Exhibit
Zoning Administrator Meaningful Connection Interpretations
Requiring Compliance with All Provisions Under B-309.1

**DEPARTMENT OF CONSUMER AND REGULATORY AFFAIRS
OFFICE OF THE ZONING ADMINISTRATOR**

Re: 1311 R Street NW - Square 0239; Lot 0129 (the "Property")

Re: 2800 16th Street NW (Square 2578, Lot 25) - Scottish Rite Temple

BUILDING SECTION

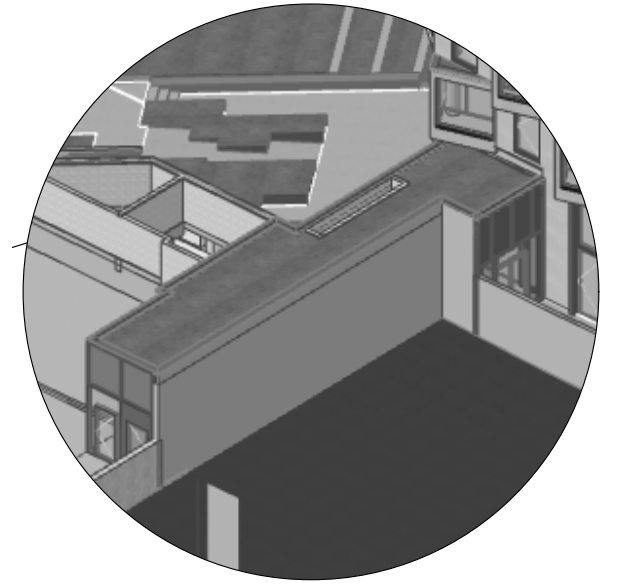
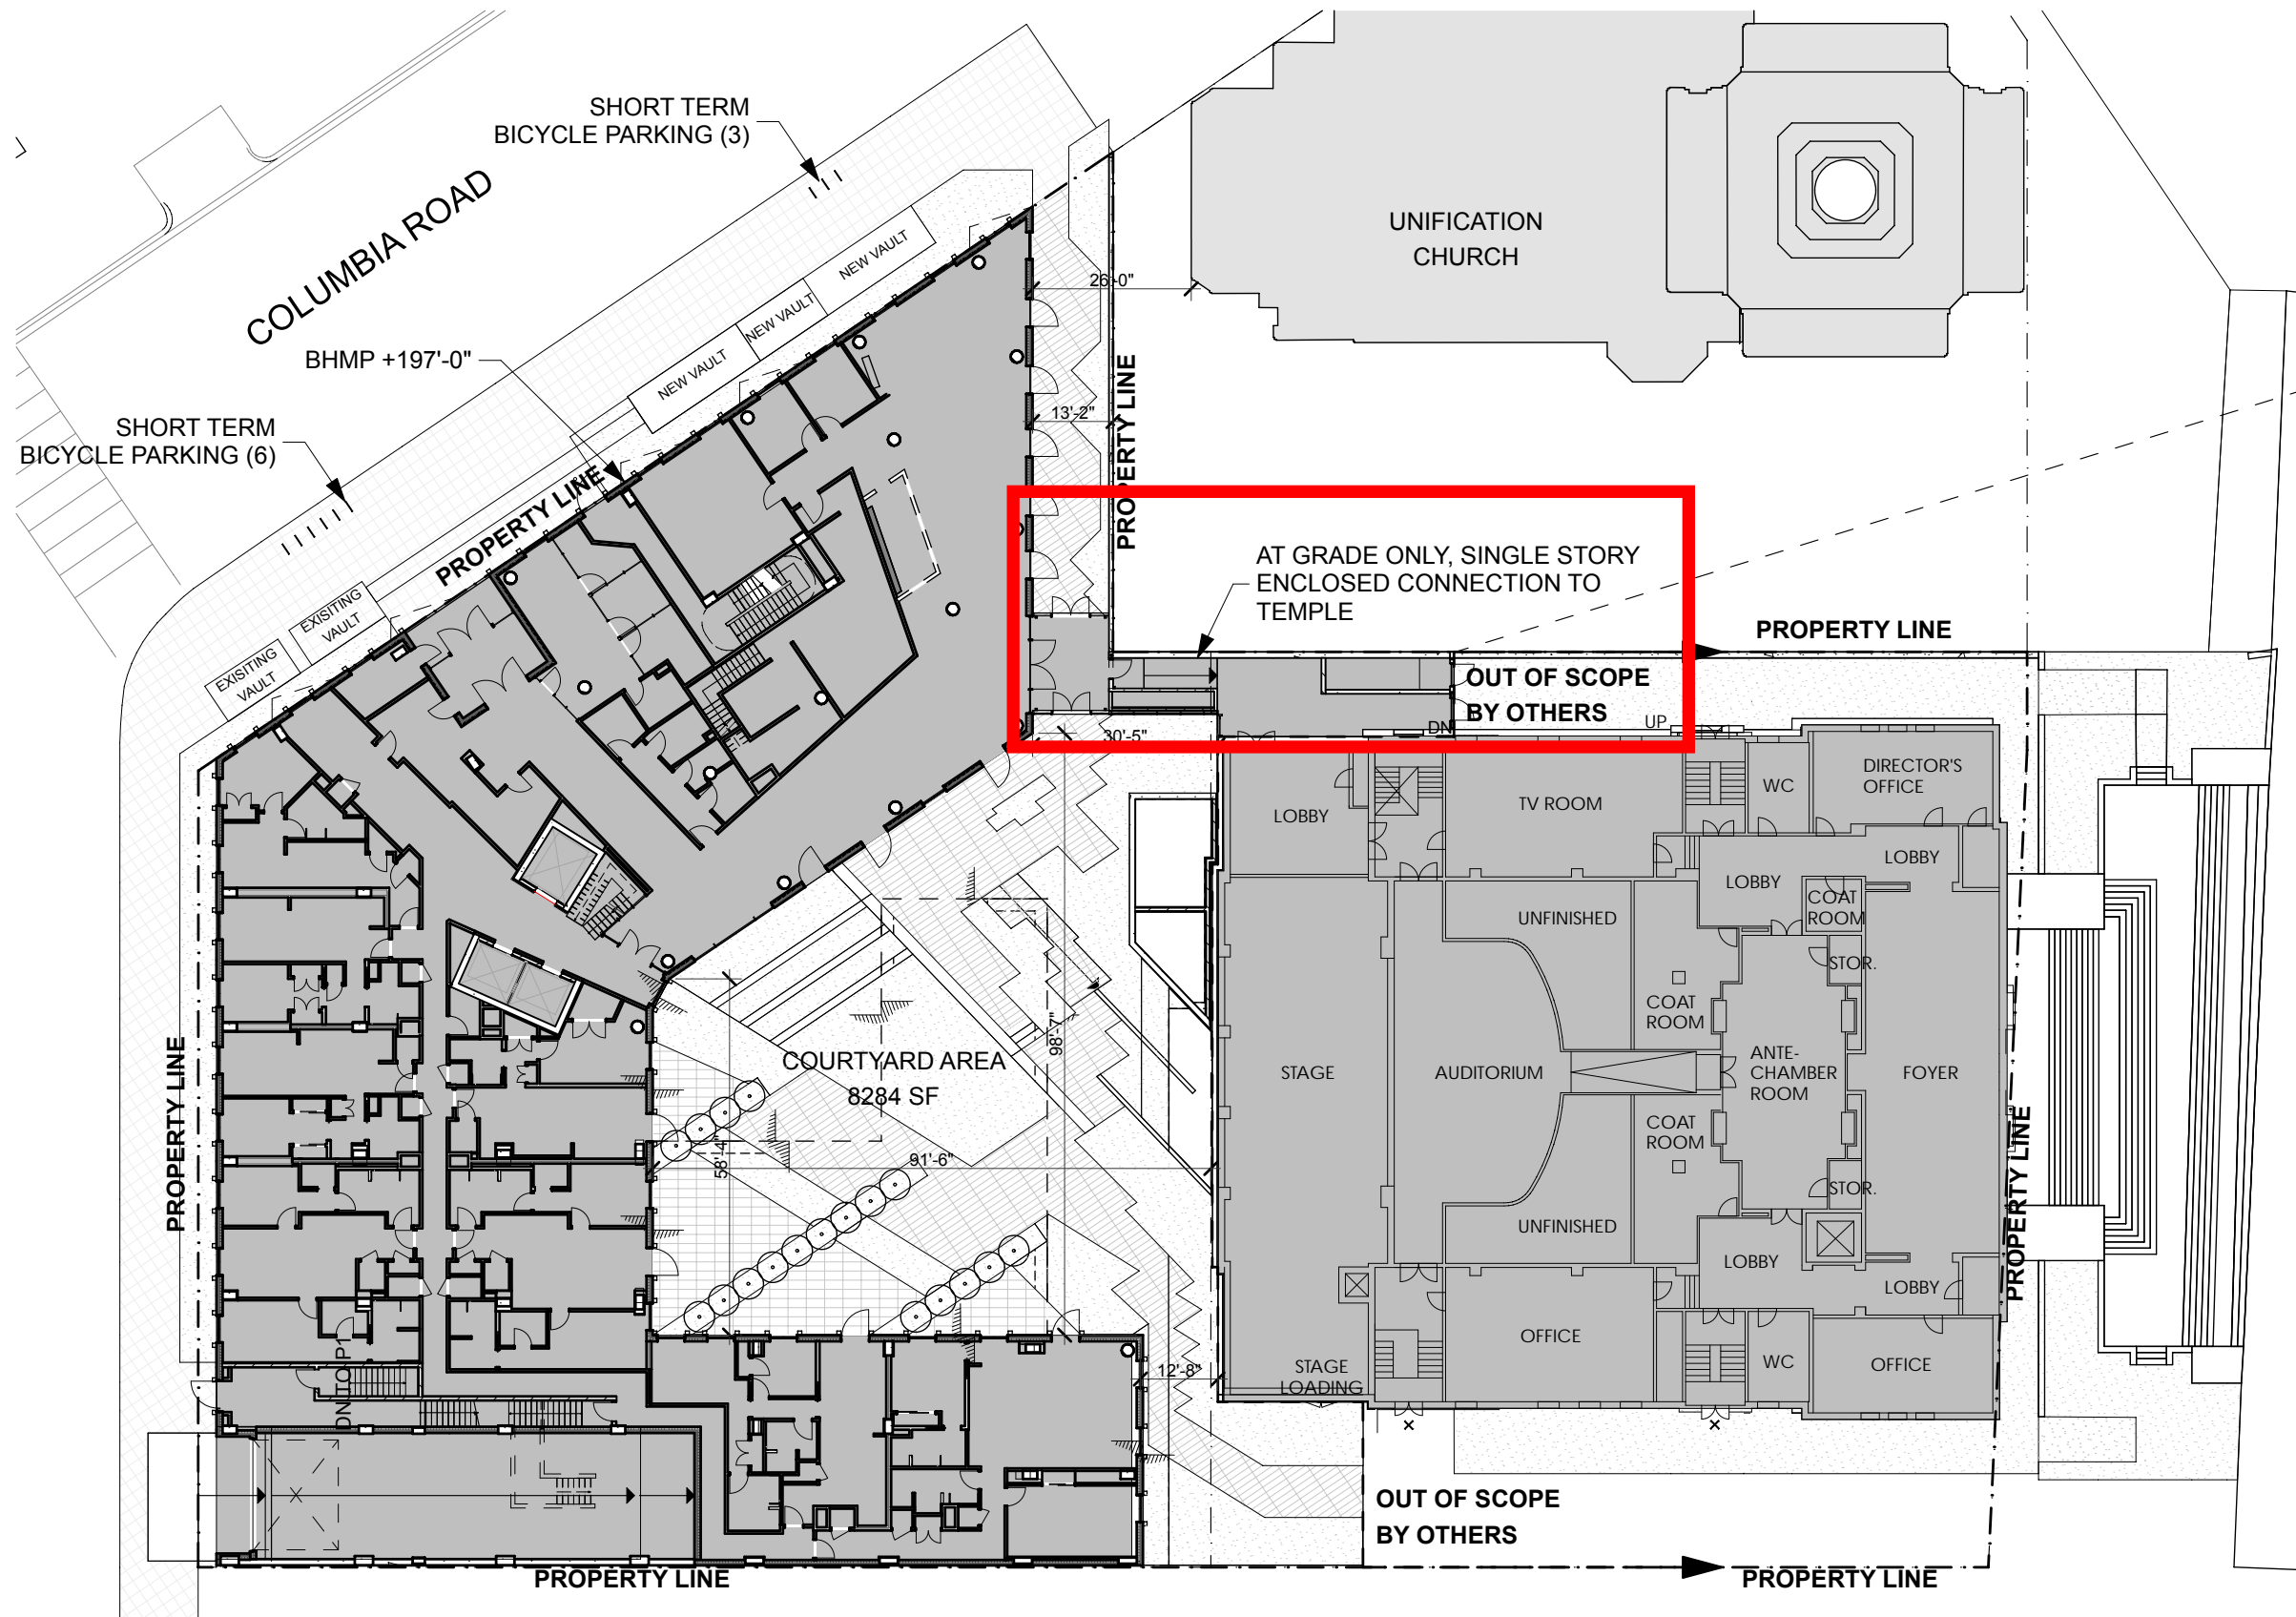
The proposed structure will comply with the requirements for a meaningful connection because a hallway connection ("Common Corridor") between the Units will be constructed fully above grade, satisfying subsection (a), and it will be enclosed, heated and artificially lit, in compliance with subsections (b-c). See Tab "B." In addition, the Common Corridor will be a space designed to provide free and unrestricted passage from the Units to the shared courtyard space, fulfilling subsection (d)(2). Both Units will have unrestricted access to the Common Corridor through doors opening from each Unit into the

corridor. Because the design satisfies Subtitle B § 309.1, the Project meets the Zoning Regulations for a single building with a meaningful connection between the Units.

Yard Diagram (Mozart Road as Front Lot Line for Rear Yard Measurement)

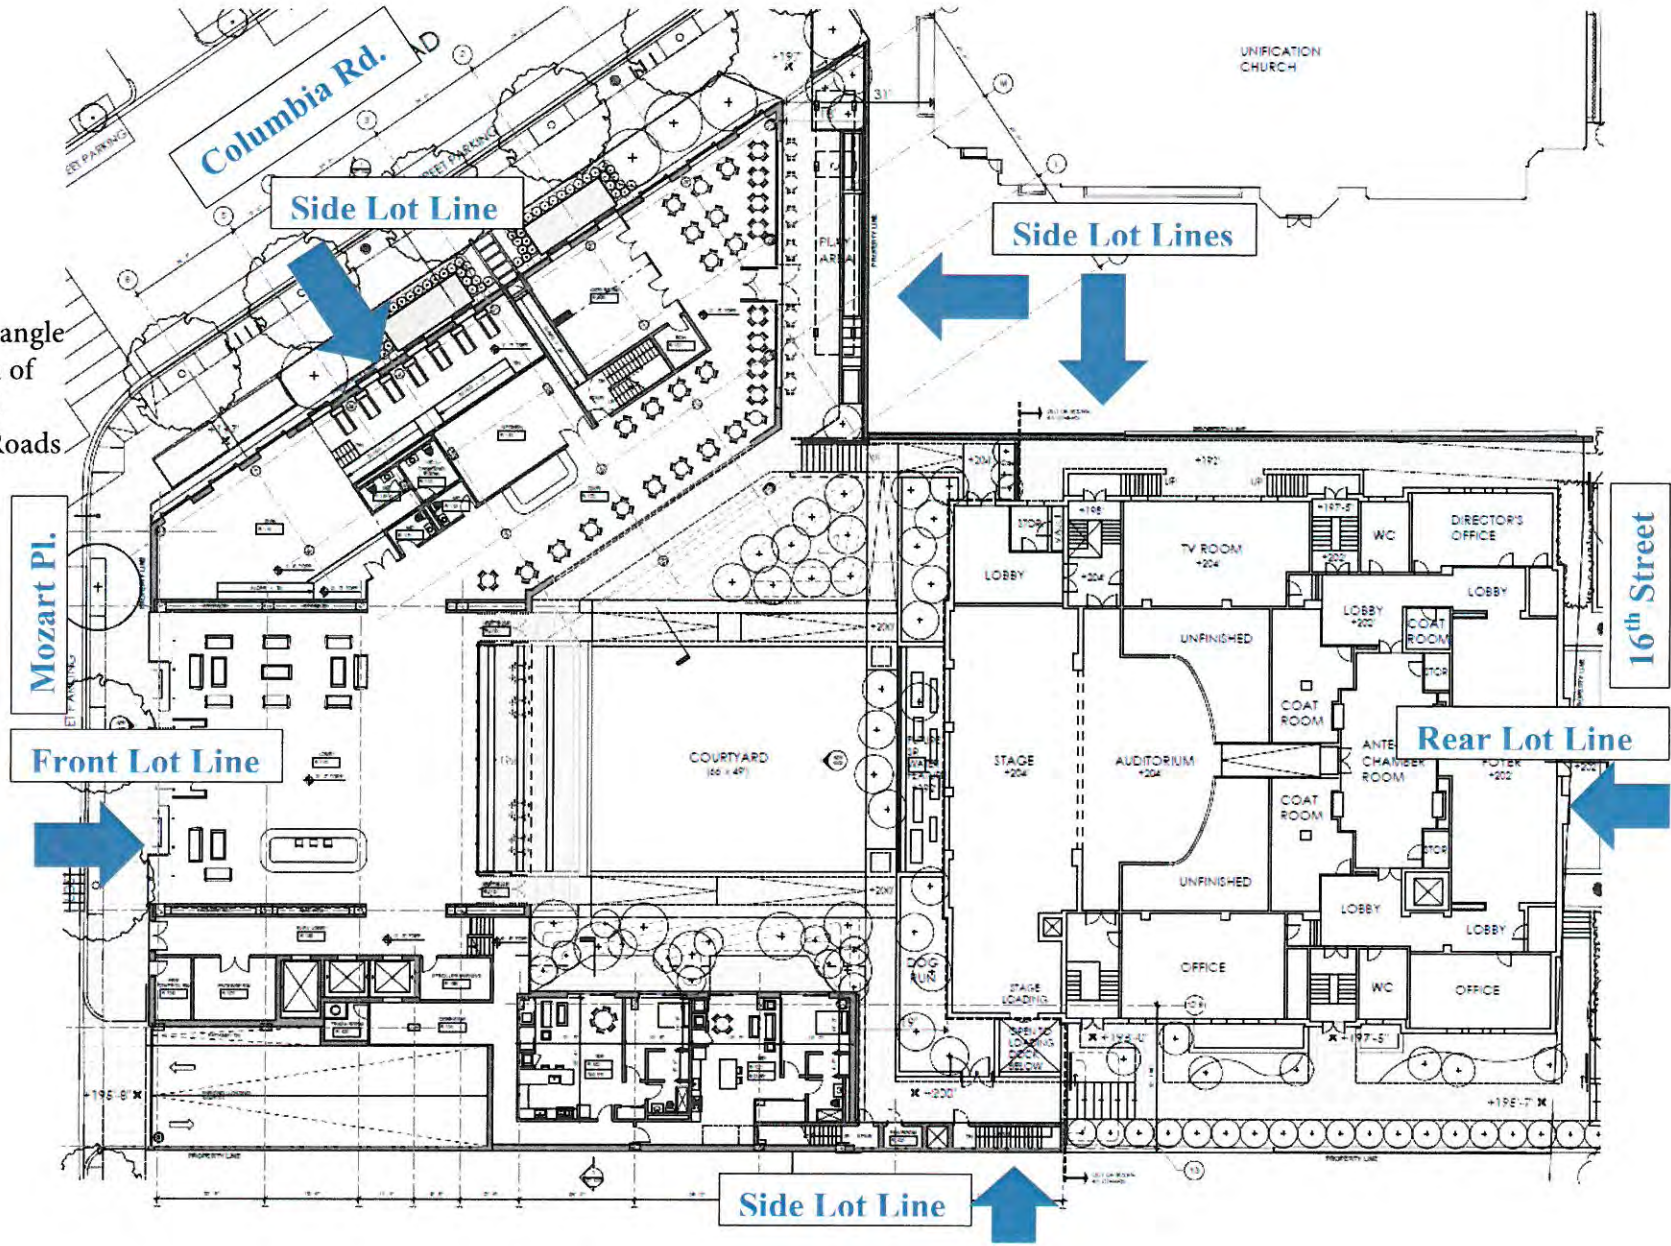
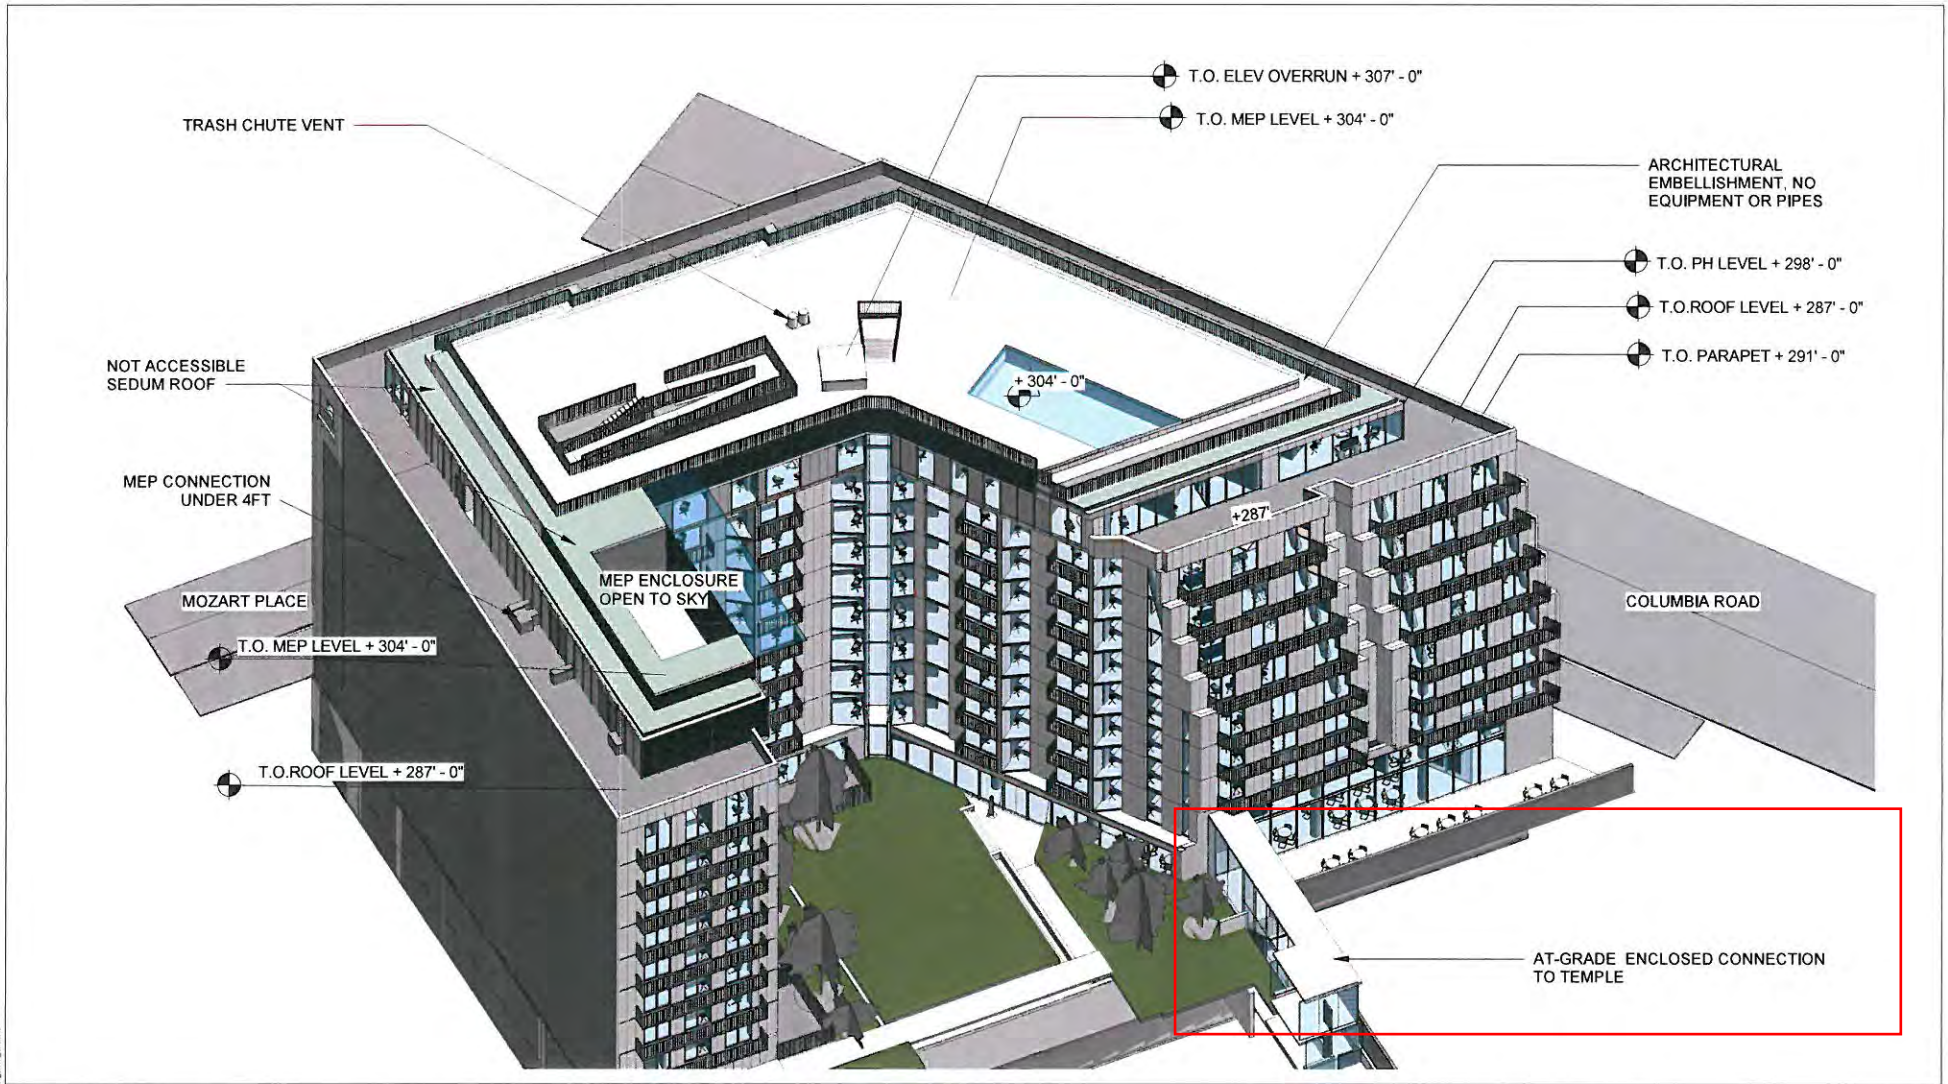
As a corner lot, the Project will identify Mozart Place NW as the front lot line, with the rear lot line along 16th Street and the side lot lines as shown in the yards diagram image at **Tab “B”**.

Accordingly, the only yard requirement is for the rear yard. The rear yard requirement in the RA-4 is 15 ft. or 4 in. per ft. of building height. Subtitle F § 305.1. Here, the proposed height for the Project is 90 ft., resulting in a rear yard requirement of 30 ft. Under Subtitle F § 305.2, because the Property is a corner lot, the depth of the rear yard is measured from the centerline of 16th Street, which is the street abutting the rear lot line. As shown in the 1913 Baist map attached to this letter at **Tab “D”**, the 16th Street right of way is 160-foot wide, making the center line of 16th Street 80 ft. from the Property’s rear lot line. Accordingly, the rear yard calculation more than satisfies the zoning requirements for rear yards in the RA-4 Zone District.

DRAWING
 3D VIEW02

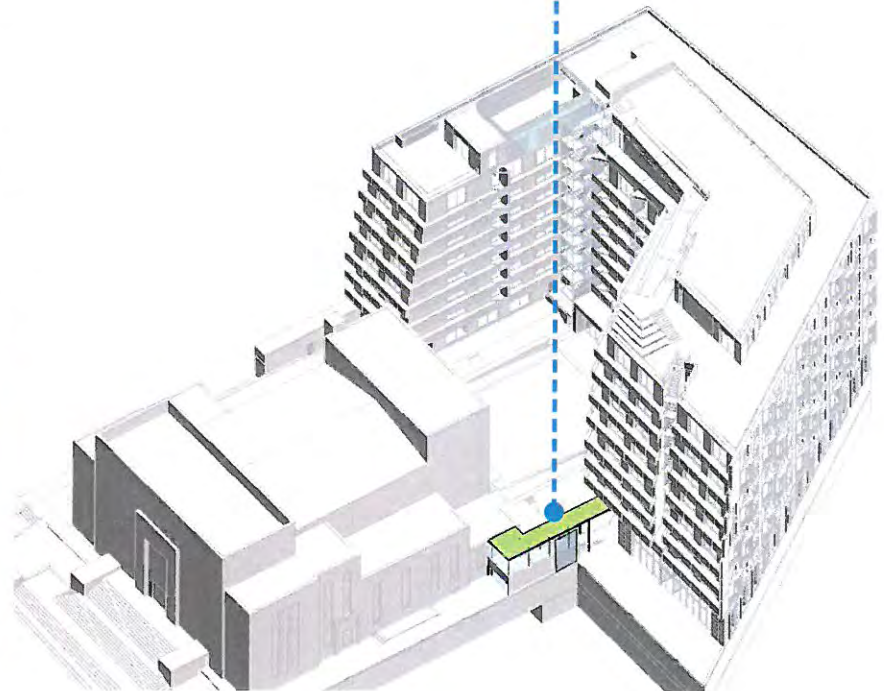
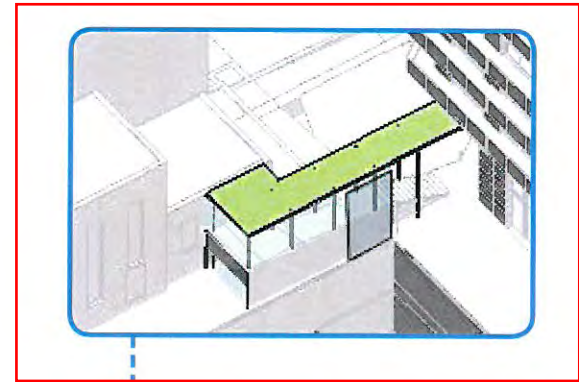
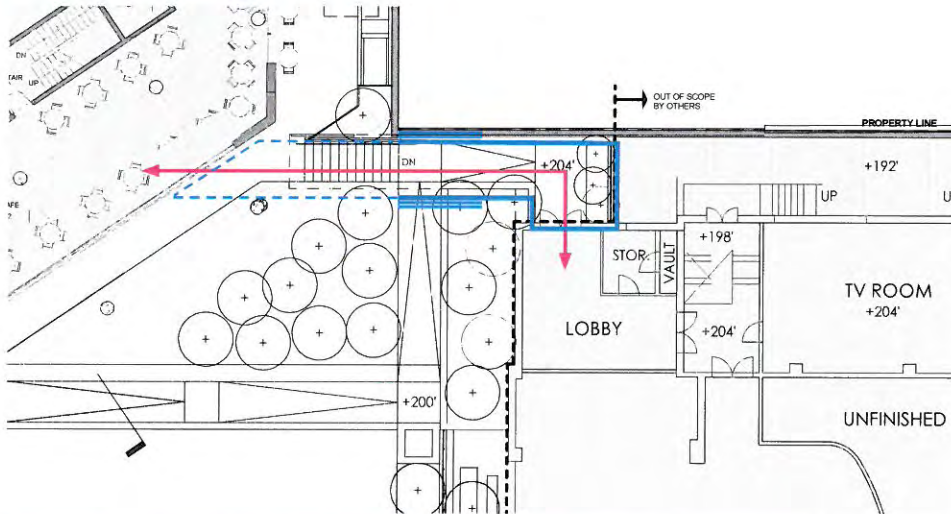
As illustrated in the Proposed Connection diagram at **Tab "C"**, the Proposed Connection between the Project and the Temple satisfies the above requirements because it is (a) above-grade, (b) an enclosed windowed walkway that includes windows that can be opened when weather permits but otherwise will be closed and secured to provide protection against the elements; (c) heated and artificially lit; and (d) common space that is designed and used to

provide free and unrestricted passage between separate portions of the building. To constitute free and unrestricted access, each building owner (your client and the Scottish Rite) must have reciprocal access rights through the Proposed Connection, although access is not required to be provided for occupants of the separate portions of the building.
